APPENDIX

Proposed Technical Specification Changes

MILLSTONE - UNIT 2

FIGURE 3.2-2a Axial Shape Index vs Fraction of Allowable Power Level per Specification 4.2.1.2c

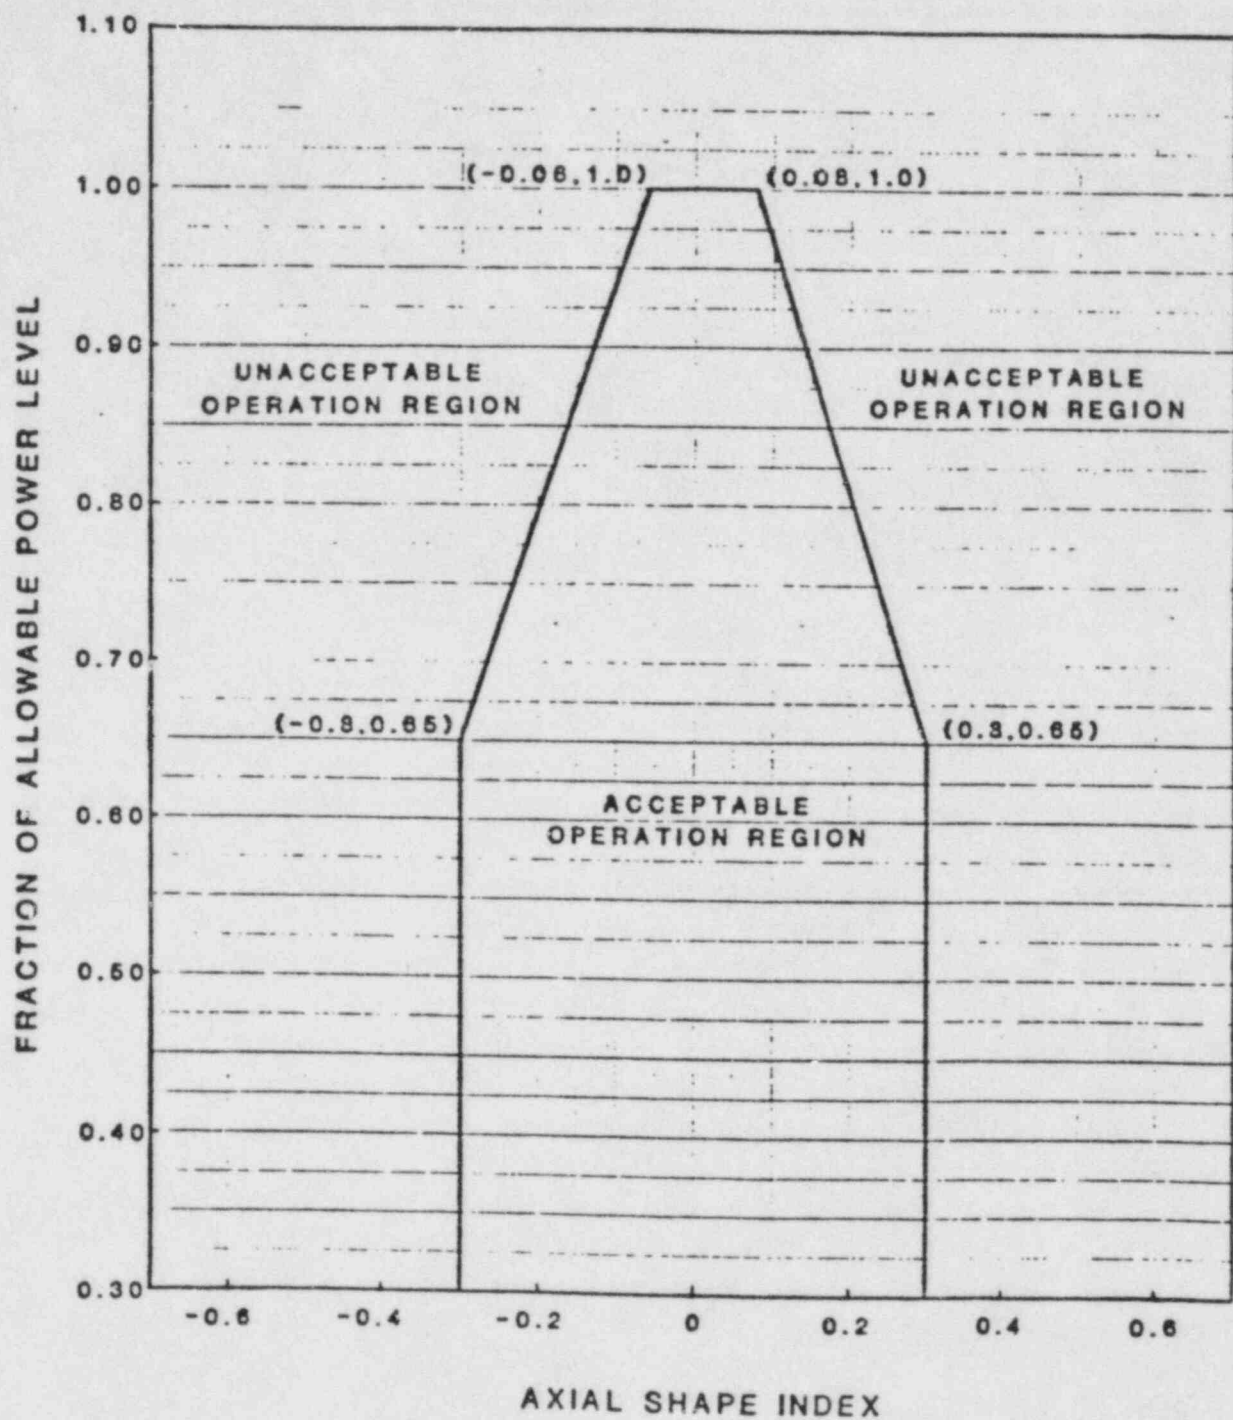
3.2.2.1 The calculated value of  $F_{xy}^T$ , defined as  $F_{xy}^T = F_{xy} (1+Tq)$ , shall be limited to  $\leq 1.62$  with the AXIAL SHAPE INDEX alarm setpoints adjusted consistent with the limits shown on Figure 3.2-2a, or

- a. With  $F_{xy}^T > 1.62$  and the AXIAL SHAPE INDEX alarm setpoints adjusted consistent with the limits shown on Figure 3.2-2a, within 6 hours either:

FIGURE 3.2-2b AXIAL SHAPE INDEX vs Fraction of Allowable Power Level per Specification 4.2.1.2c

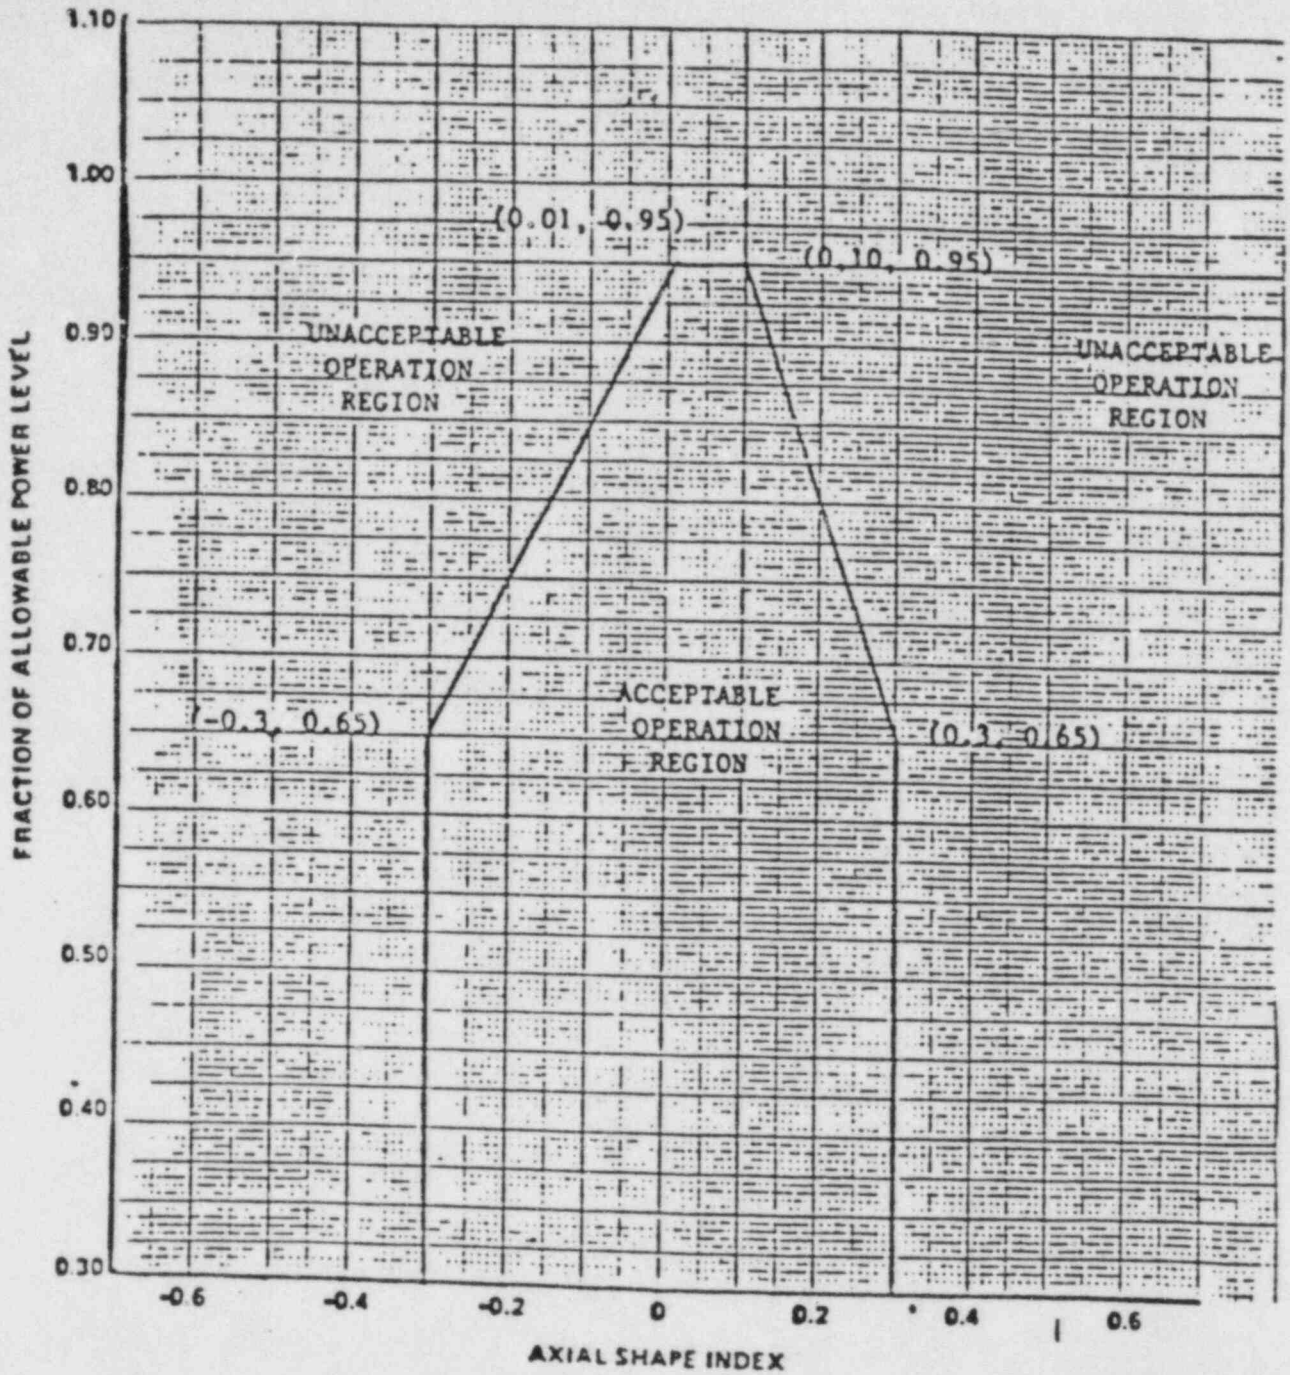
3.2.2.2 The calculated value of  $F_{xy}^T$ , defined as  $F_{xy}^T = F_{xy} (1+Tq)$ , shall be limited to  $\leq 1.719$  with the AXIAL SHAPE INDEX alarm setpoints adjusted consistent with the limits shown on Figure 3.2-2b.

- 2) Apply the limits of Specification 3.2.2.2 and Figure 3.2-2b and within 72 hours adjust the AXIAL SHAPE INDEX alarm setpoints consistent with the limits shown on Figure 3.2-2b, or

FIGURE 3.2-3a Total Radial Peaking Factor vs Allowable Fraction of Rated Thermal Power

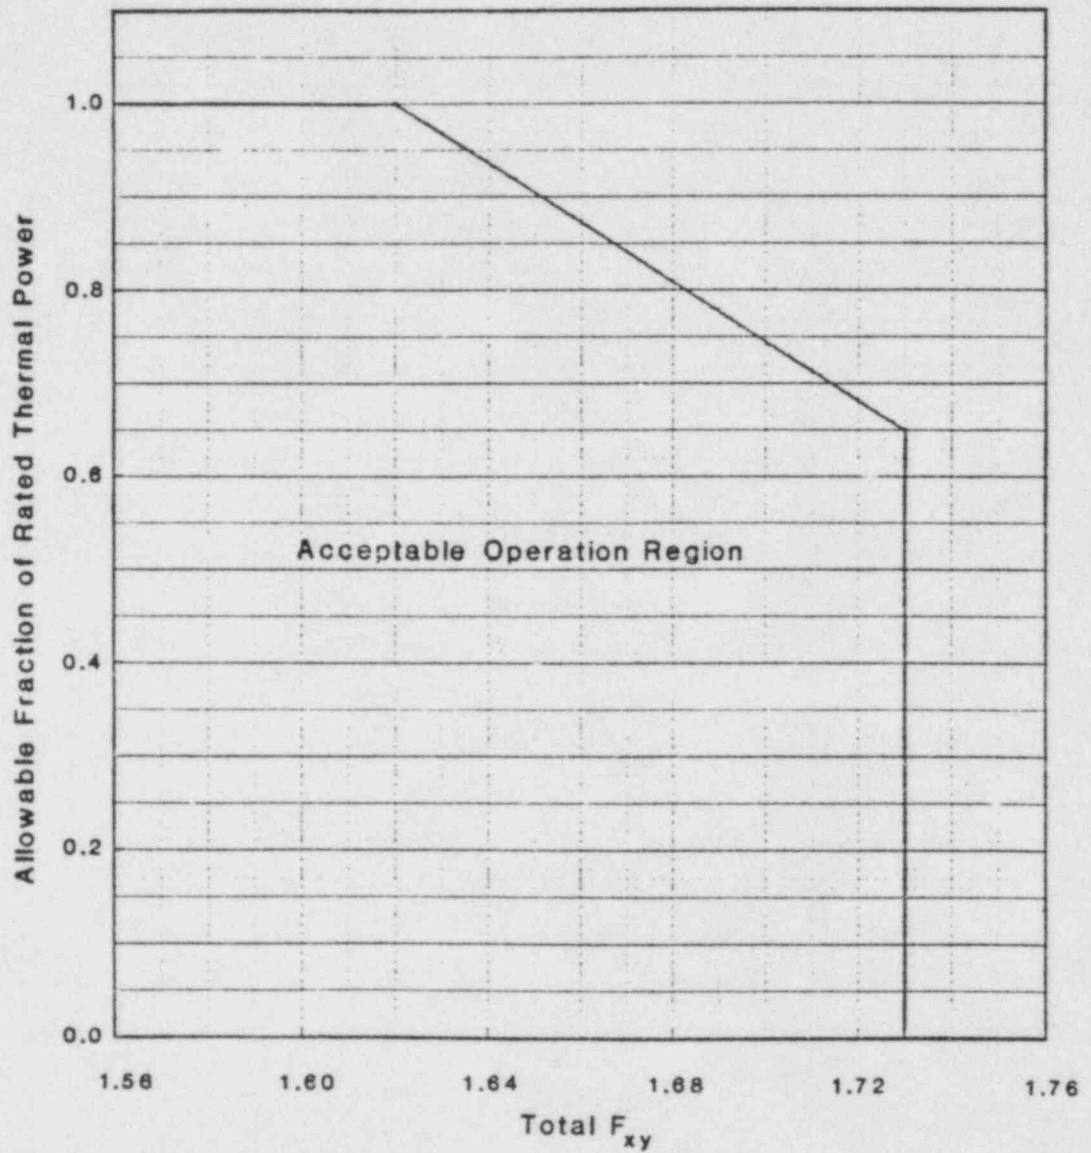
- 1) Reduce THERMAL POWER to bring the combination of THERMAL POWER and  $F_{xy}^T$  to within the limits of Figure 3.2-3a and withdraw the full length CEAs to or beyond the Long Term Steady State Insertion Limit of Specification 3.1.3.6, or

FIGURE 3.2-3b Total Thermal Peaking Factor Versus Allowable Fraction of Rated Thermal Power

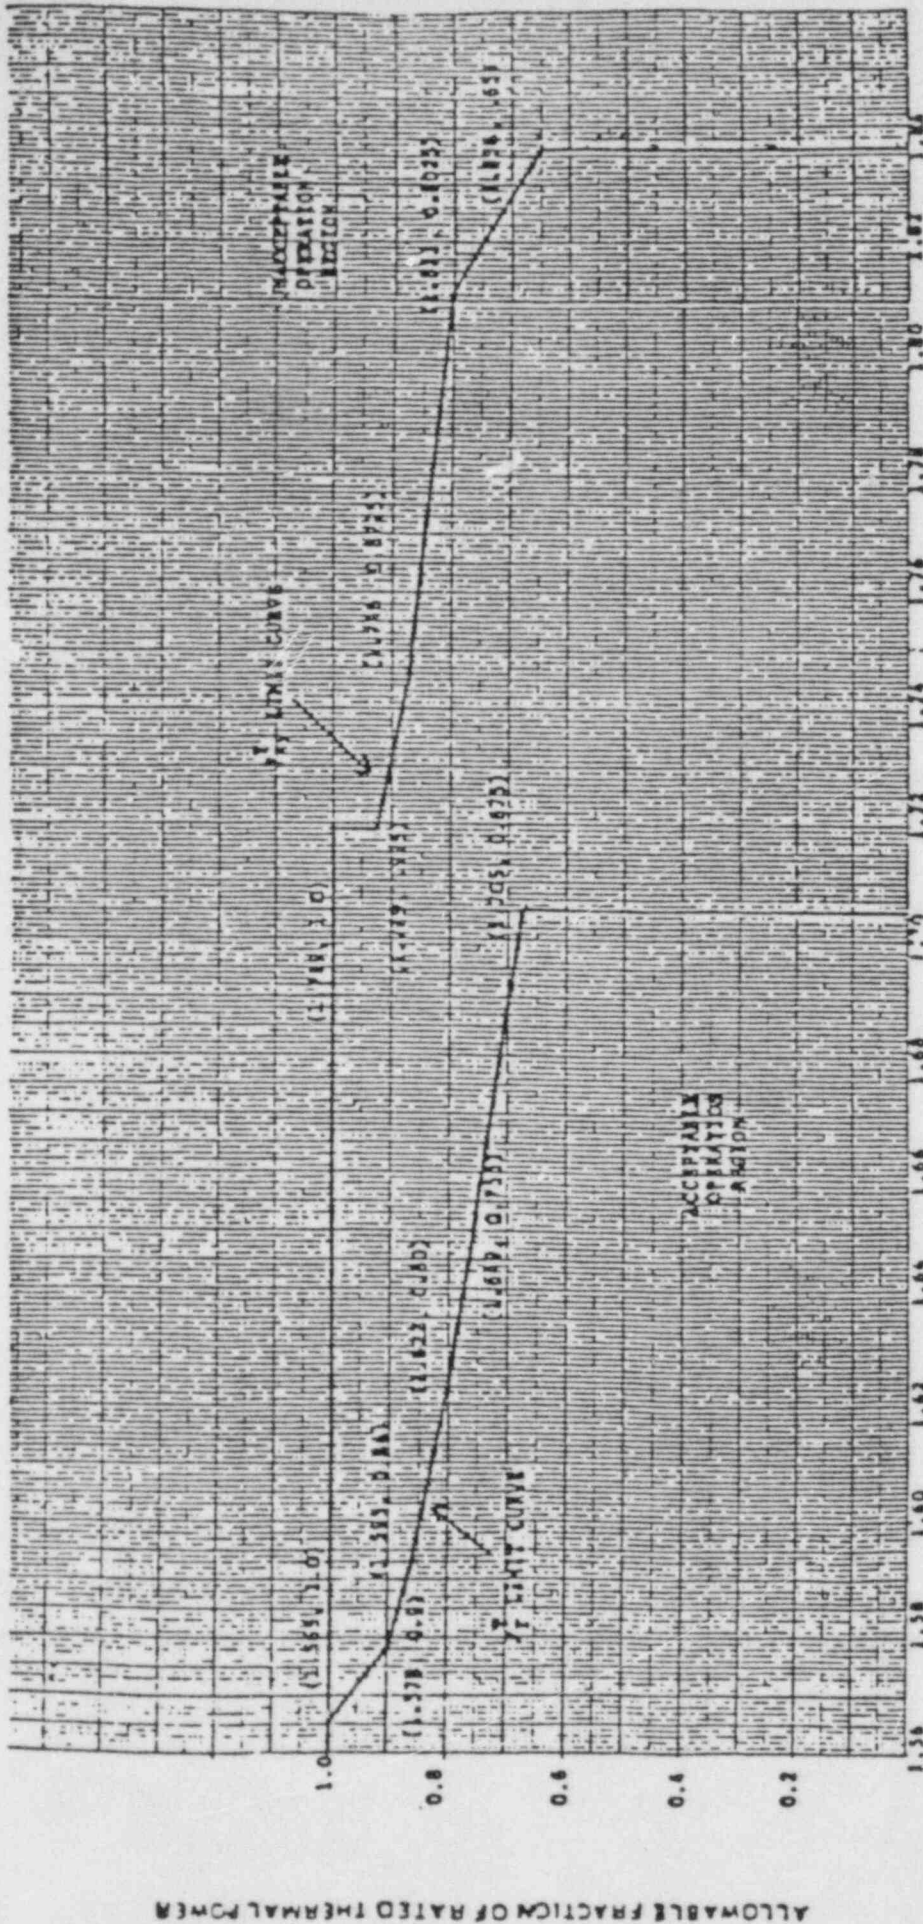
- 1) Reduce THERMAL POWER to bring the combination of THERMAL POWER and  $F_{xy}^T$  to within the limits of Figure 3.2-3b and withdraw the full length CEAs to or beyond the Long Term Steady State Insertion Limit of Specification 3.1.3.6, or

- a. Reduce THERMAL POWER to bring the combination of THERMAL POWER and  $F_r^T$  to within the limits of Figure 3.2-3b and withdraw the full length CEAs to or beyond the Long Term Steady State Insertion Limits of Specification 3.1.3.6; or
- b. Be in at least HOT STANDBY.
